**STATE OF MINNESOTA
STEARNS COUNTY BOARD OF COMMISSIONERS
SITTING AS THE DRAINAGE AUTHORITY FOR
STEARNS COUNTY DITCH 28**

**In the Matter of:
the Reestablishment of Stearns County
Ditch 28 Drainage System Records**

**FINDINGS AND ORDER
REESTABLISHING DRAINAGE
SYSTEM RECORDS**

Re: Stearns County Ditch 28, Reestablishment of Records Technical Memorandum

Figure 2: Stearns Co. CD 28 ROW

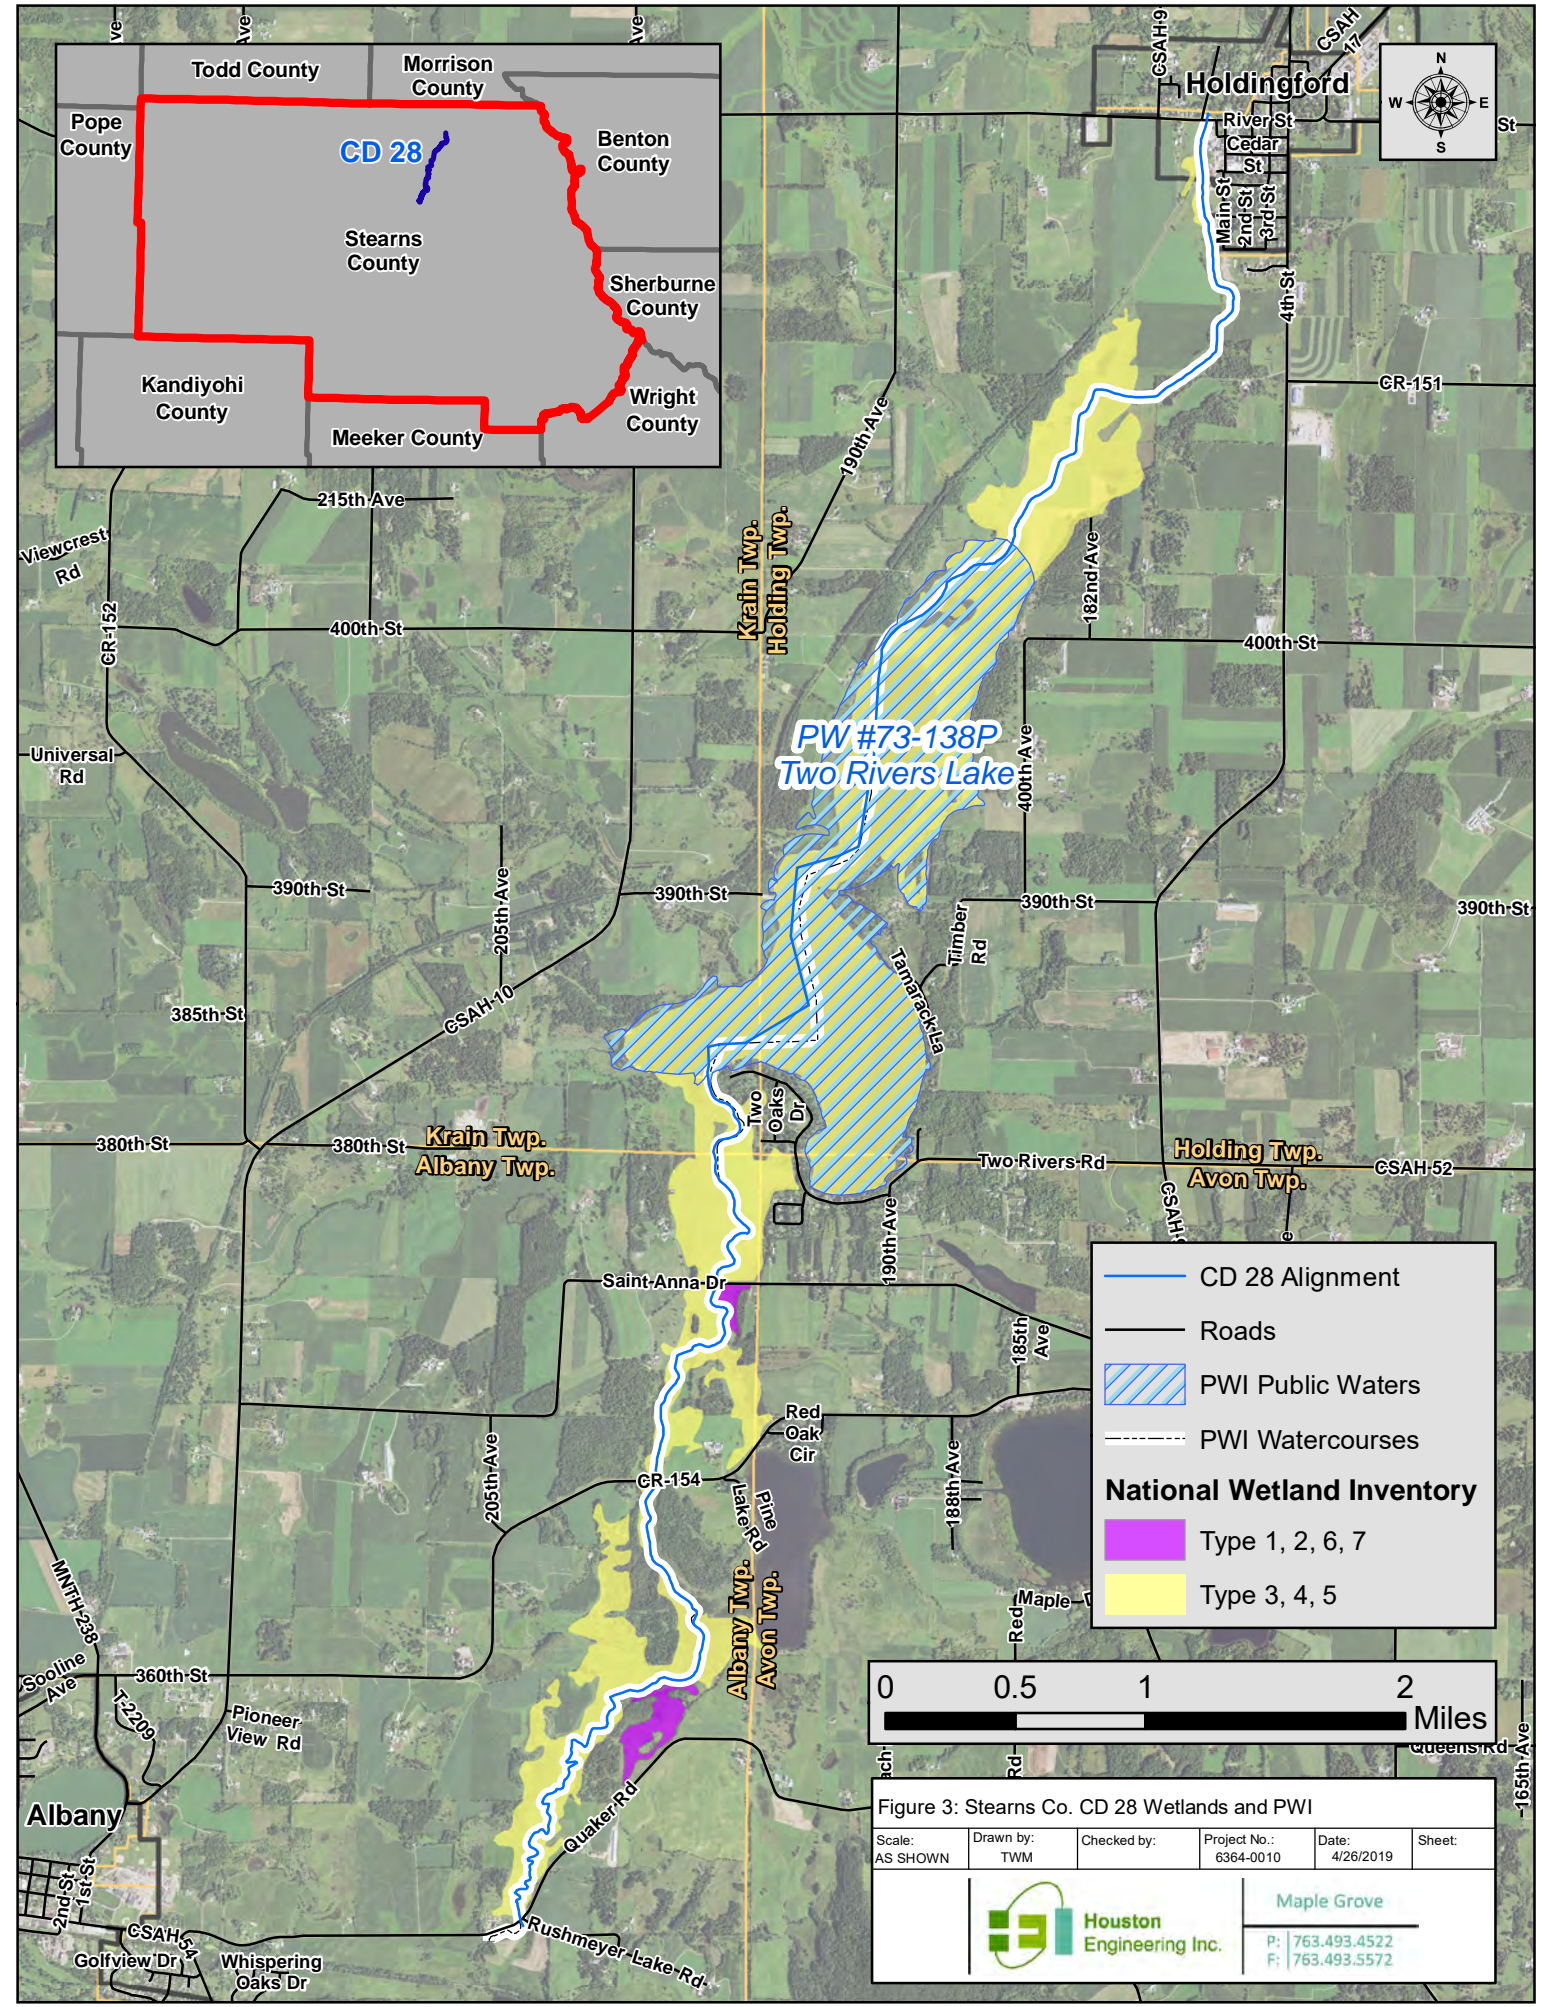
4. **Right-of-Way [ROW]** (page 5 and 6) “Along portions of the public drainage system where excavation did not occur, the ROW is 55 feet centered on the ditch centerline.”

- We disagree with this statement and with the dimensions listed in Table 1. The Report claims the entire width of the watercourse as ROW for the purpose of excavation. The plans for the establishment of the ditch called for a 1:1 slope and **10 foot ditch bottom with an average top width of 18 feet**. The first entry in Table 1, Station 90 +72 to 95 +38 portion of upstream of Two Rivers Lake, was never excavated at all, yet it’s listed as an 80’ ROW. The second entry in Table 1 extends beyond the area that was excavated in 1906 (Station 103 + 08 to 120 + 37) and claims 90’ ROW. When the ditch was

constructed downstream of Two Rivers Lake, it had a bottom width of 10 feet. Over time, the river has widened to anywhere from 40 – 60 feet wide (or more). Somewhere within the bed of the river, the original ditch configuration exists. To claim the widening of the ditch from 10 foot bottom to 60 foot (showing a minimum ROW of 100 feet and maximum ROW of 120 feet) would be a significant improvement to the drainage system.

DNR	19-Aug	Written	Attached comment 4, bullet point 1	No	The report has been revised to provide clarity regarding the ROW. It is important to note that the report is not proposing an expansion of the ditch bottom beyond 10-feet and that the ROW is not exclusively for excavation, but also for access adjacent to the public drainage system to complete inspection and maintenance activities. Table 1 within the report has been corrected to reflect the stationing of the areas where excavation did originally occur at the time of construction for the ROWs greater than 55 feet.
DNR	19-Aug	Written	Attached comment 5, bullet point 1	No	The 2015 data was commissioned by the Two Rivers Lake Association to address work on the drainage system prompted by the Association. The focus of the data was not for purposes of reestablishing drainage system records under 103E.101, subd. 4. The appointed engineer and staff have completed a more thorough investigation of evidence to define the alignment; cross-section; profile; dimensions; elevations; and right-of-way of the drainage system as constructed than the work commissioned in 2015. The comment provides no evidence to the drainage authority contradicting the additional findings and evidence completed by HEI.

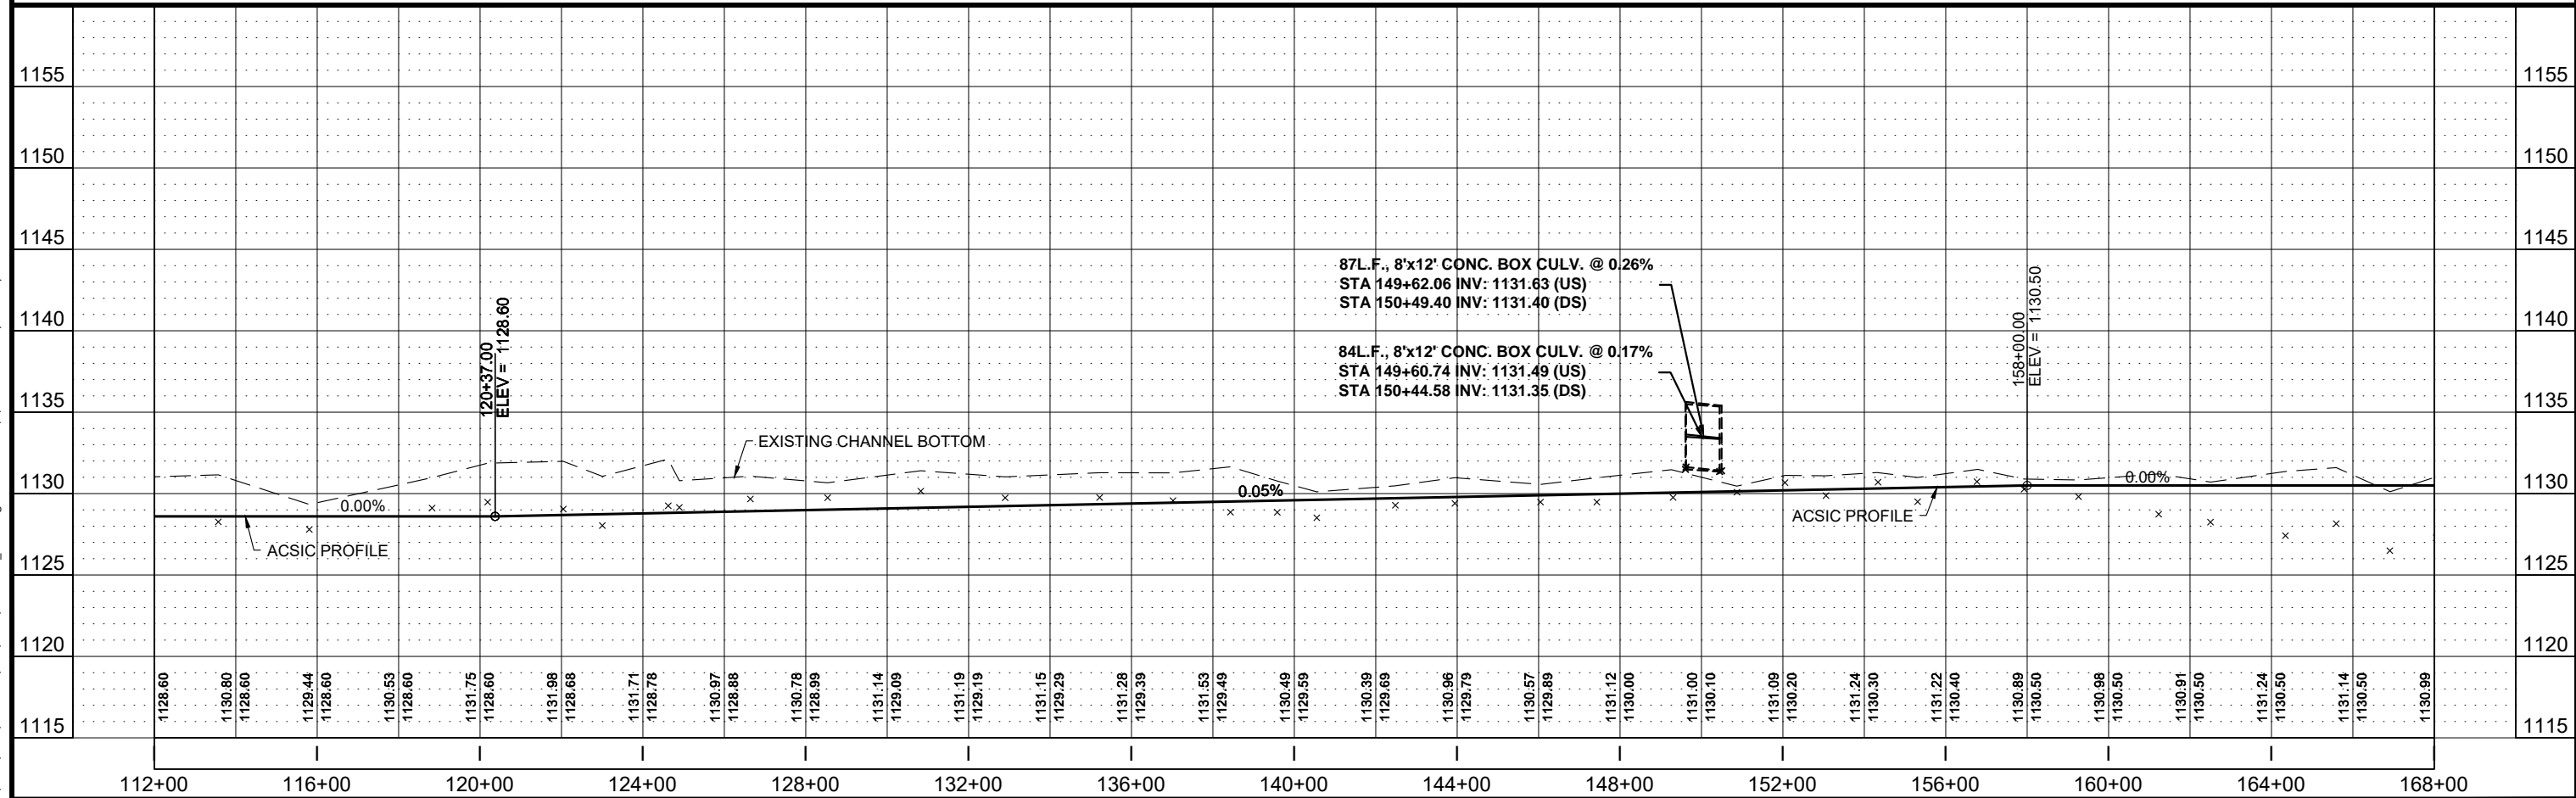
- The proposed ACSIC from Station 112+00 (upstream) and 168+00 (downstream) requires water to run uphill before continuing to flow downstream [elevations 1126.8 to 1130.5]. This would not appear to be consistent with repairing to the necessary hydraulic capacity of the drainage system. The public watercourse that connects Pine Lake (73-136P) to CD 28 exists within this section. Excavation to the ACSIC has the

potential of creating headcutting in the public watercourse and the possibility of affecting the runout elevation of the lake, creating a negative (drainage) impact.
